Work Order ID 130346

Item Name: Quick Release Basket and Long Cargo Tube Mounting, Fits LH or RH

DART SERVICE INSTRUCTION

**TO AMEND INSTALLATION INSTRUCTIONS D350-607-3 Rev.D,
INSTALLATION INSTRUCTIONS D350-607-4 Rev. C AND
INSTRUCTIONS FOR CONTINUED AIRWORTHINESS ICA-D350-607 REV. 6**

FIGURE 1: INSTALLATION OF D4775-041 FWD STRUT

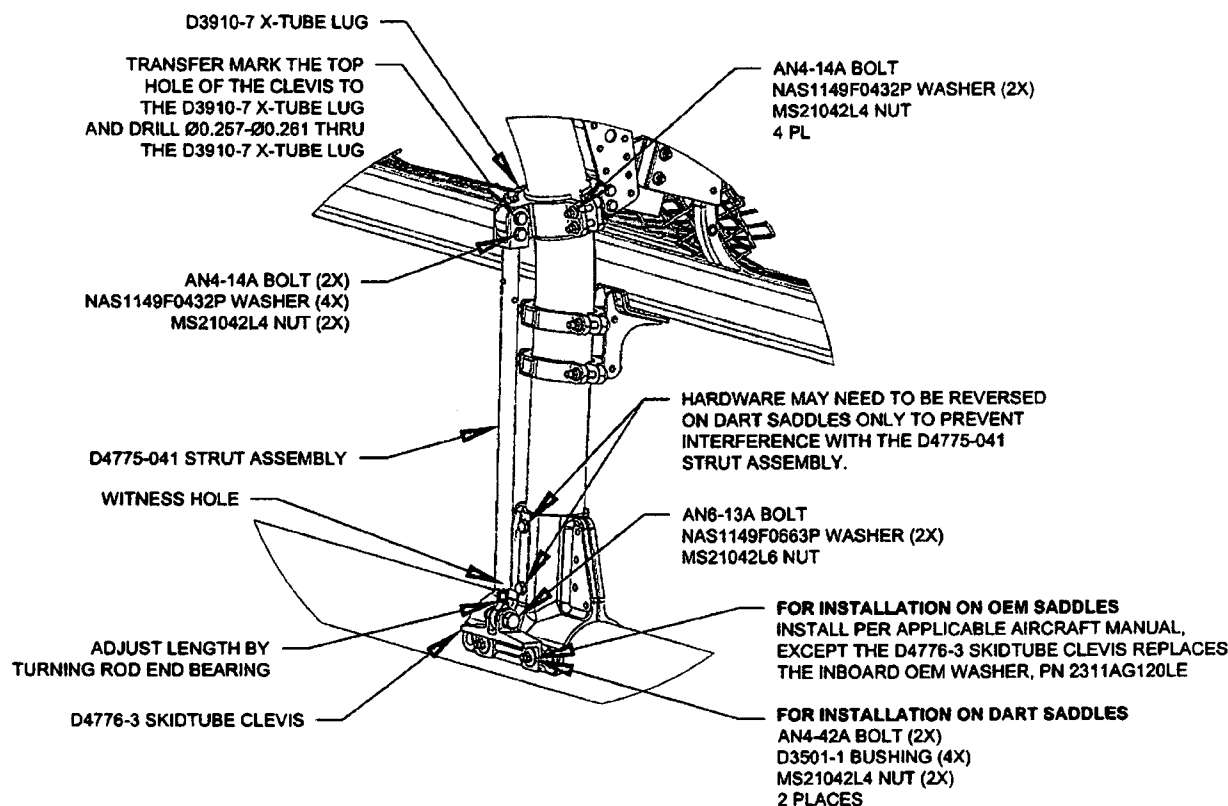
3.1 Substitute the Forward Lower D3910-5 X-Tube Lug with the D3910-7 X-Tube Lug as shown in Figure 1.

3.2 Install the forward D4775-041 Strut Assembly. Transfer mark from the upper hole on the clevis of the D4775-041 Strut Assembly to the D3910-7 X-tube Lug and drill thru the lug $\varnothing 0.257$ - $\varnothing 0.261$ as shown in Figure 1. Touch up chemical conversion coating per MIL-DTL-5541. Check the witness holes located at the bottom end of the D4775-041 Strut Assemblies to ensure that the thread from the rod end extends past the witness hole.
Torque MS21042L4/-4 nuts to 50-70 in-lbs (5.7-7.9 N-m). Torque MS21042L6/-6 nuts to 160-190 in-lbs (18.1-21.5 N-m).
